MATANUSKA-SUSITNA BOROUGH PLATTING BOARD AGENDA

**AUGUST 6, 2020
REGULAR MEETING
1:00 P.M.**

PRELIMINARY PLAT: FAIRVIEW MEADOWS 2019

REQUEST: The request is to create 11 lots and 1 tract, by a three phase Master Plan, from Tax Parcels A18 and D14, to be known as **GARRISON RIDGE**, containing 39.9 acres +/- . Petitioner is vacating a portion of the Public Use Easement of N. Prospect Drive; the Section Line Easements on the north; dedicating the Public Use Easement of N. Meadow Lakes Loop and additional right-of-way to straighten N. Meadow Lakes Loop. Two cul-de-sac will be created for access. The property is located north and south of N. Meadow Lakes Loop, and west of N. Phillips Drive (Tax ID #s 218N02W28D014 and 218N02W33A018); within the S ½ SE ¼ Section 28 and N ½ NE ¼ Section 33, Township 18 North, Range 02 West, Seward Meridian, Alaska. In Community Council: Meadow Lakes and in Assembly District #7 Tam Boeve

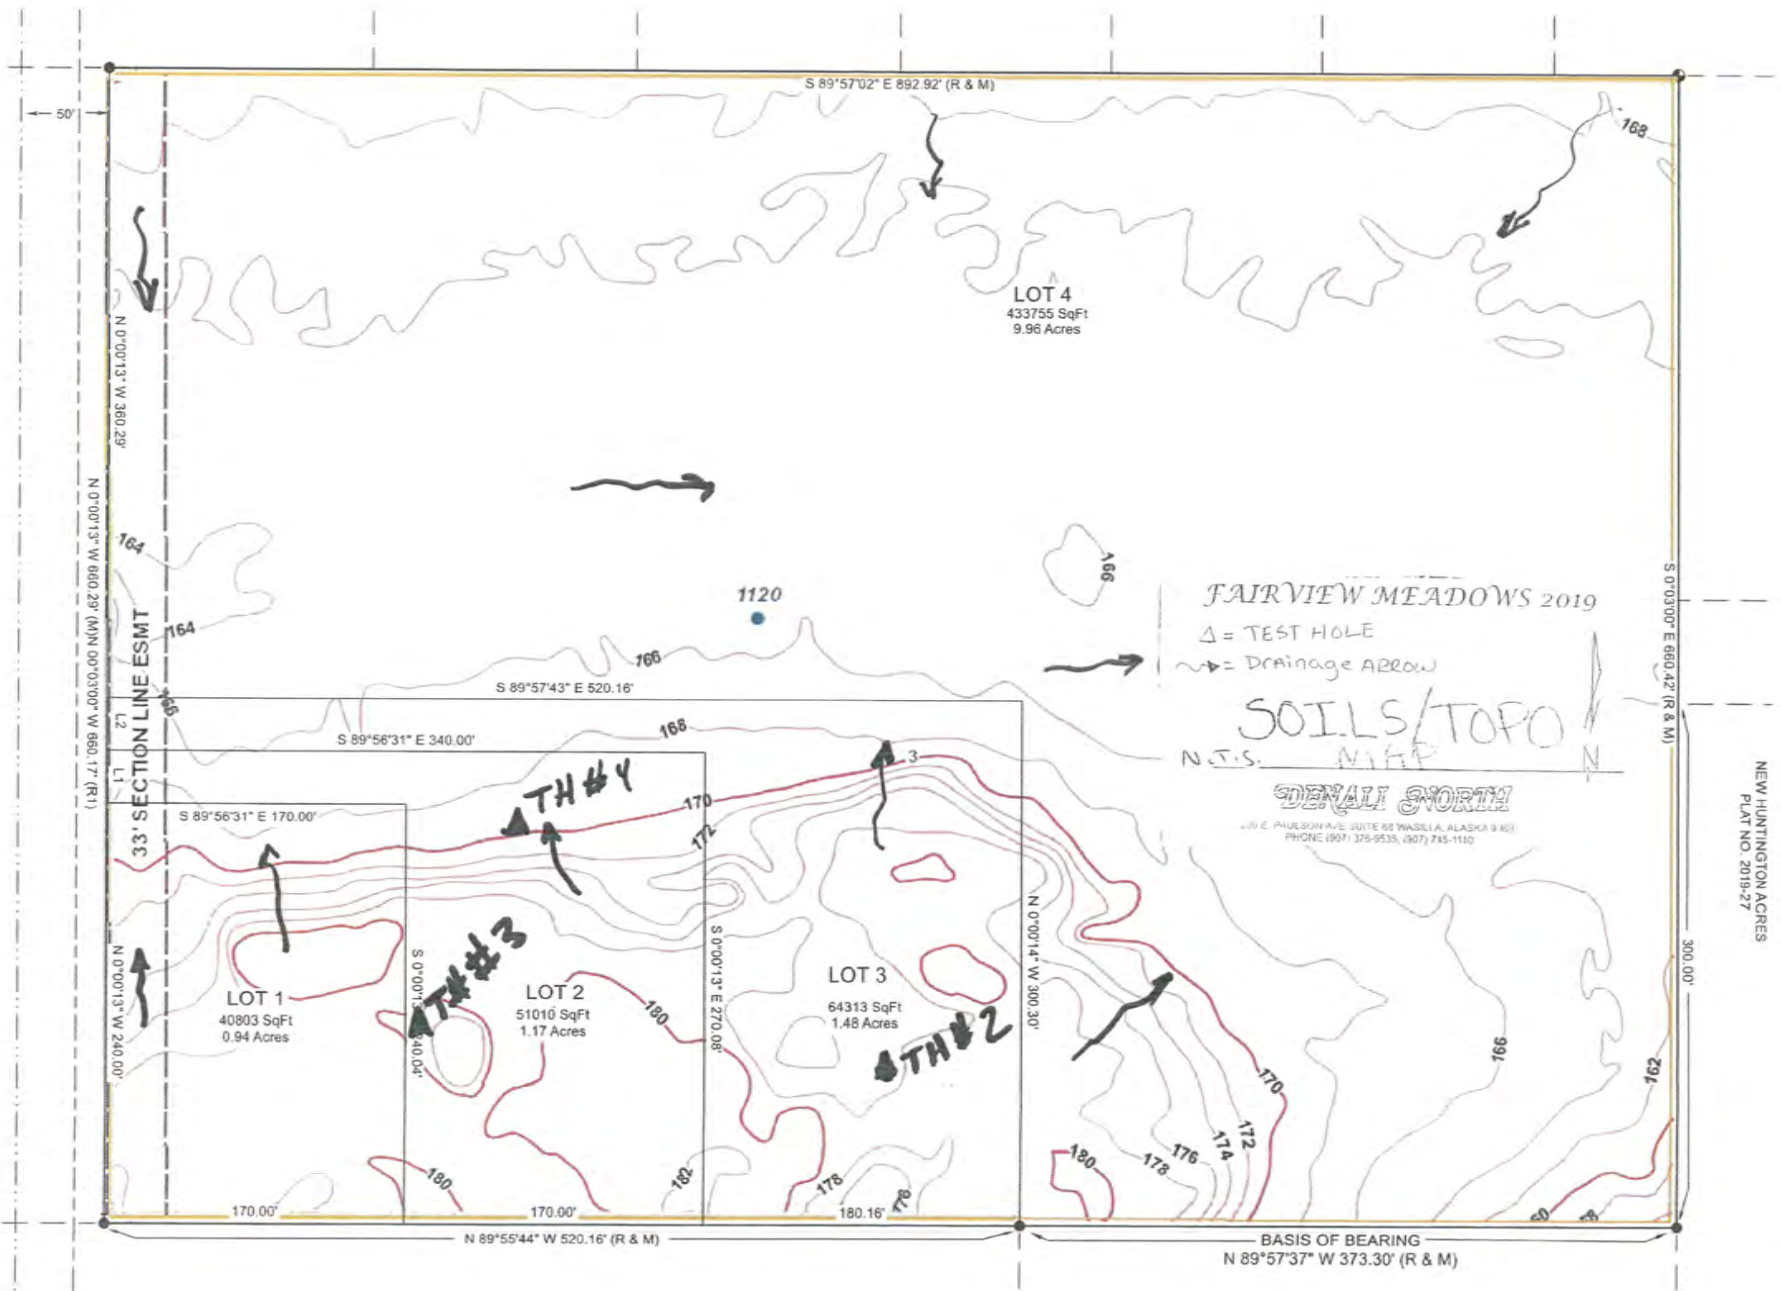
The Redesign of the plat does not affect the useable area as shown on the attached topo map. The lot lines were adjusted to maintain 0.94 to 1.48 acres lot sizes. The sight distances for this access point are shown on the attached sight distance drawing and the required distances are highlighted.

EXHIBIT G-2

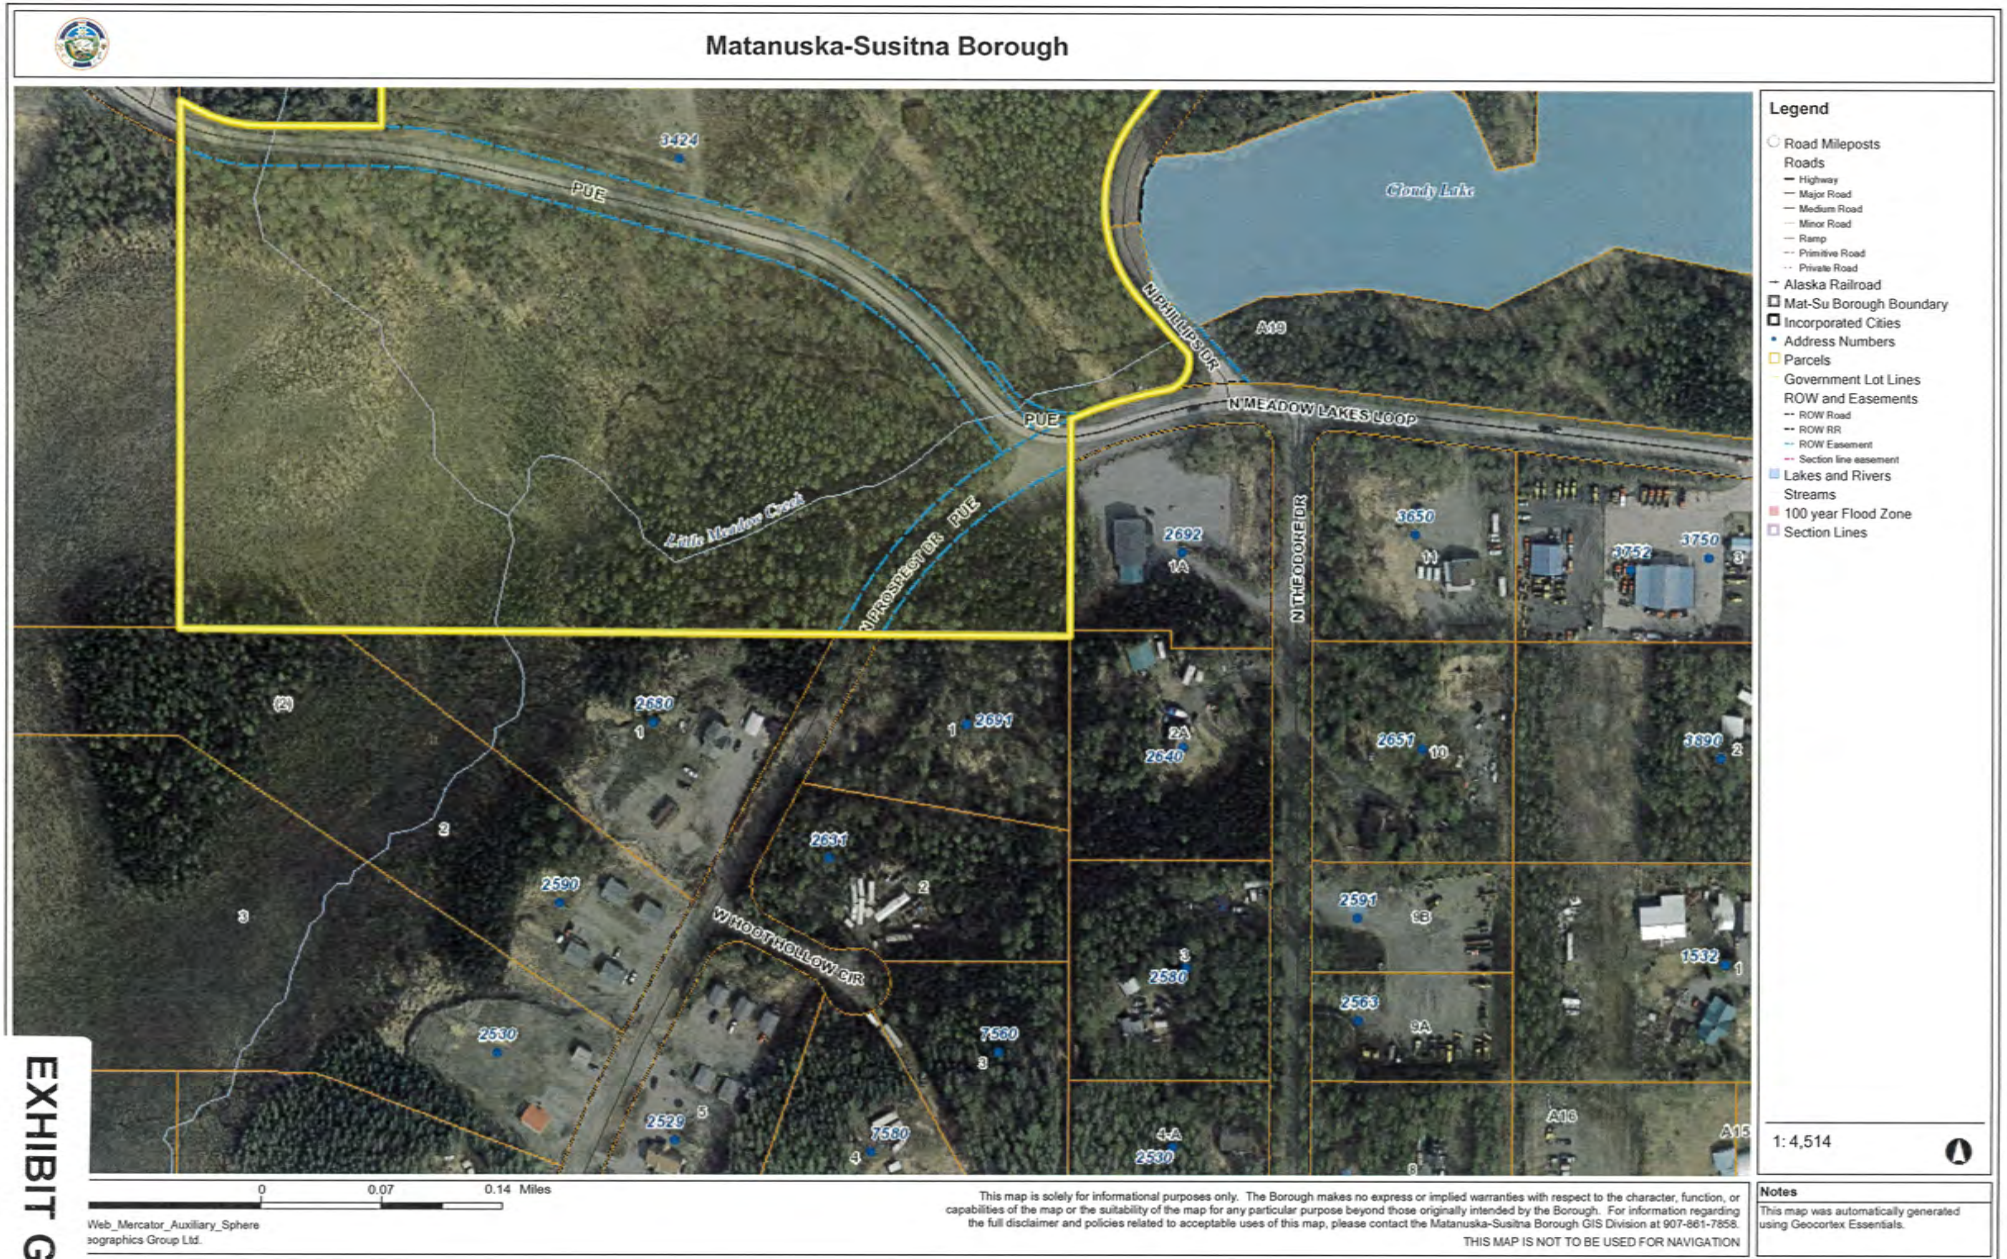
- (2) Wetlands complex is this area, see attached wetlands map (see **Exhibit G-2**).
- (3) The realignment of N. Meadow Lakes Loop to remove the curve with the dangerous sightlines and realignment of N. Phillips Drive to provide proper separation from N. Theodore Drive is absolutely a must for safety.

- 2) Wetlands complex is in the area, see attached wetlands map.
- 3) The realignment of meadow lakes loop to remove the curve with the dangerous sightlines and realignment of Phillips Dr. to provide proper separation from Theodore Dr. is absolutely a must for safety.
